Service Bulletin

02-152

02 - Cab Exterior

New faux door panel for fairing to replace old panel with insufficient weld.

Figure 2

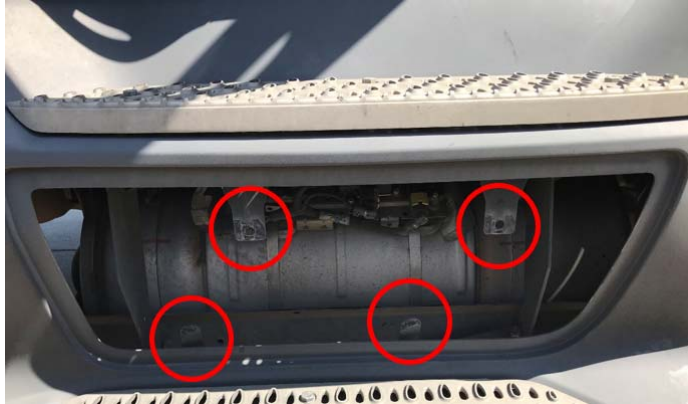
2. Visually inspect the panel for signs of being loose and lightly tap to listen for rattling.
3. If loose or rattling, remove panel assembly and inspect for separation as shown in Figure 2.
 - Locate the four mounting bolts behind the panel that are accessible from the underside of the fairing (see Figure 3).
 - Remove the four 10mm bolts holding the panel to brackets. If access to these bolts is difficult, the fairing may be removed by removing six 17mm step bolts.

Do not fully separate the panel skin from the reinforcement.
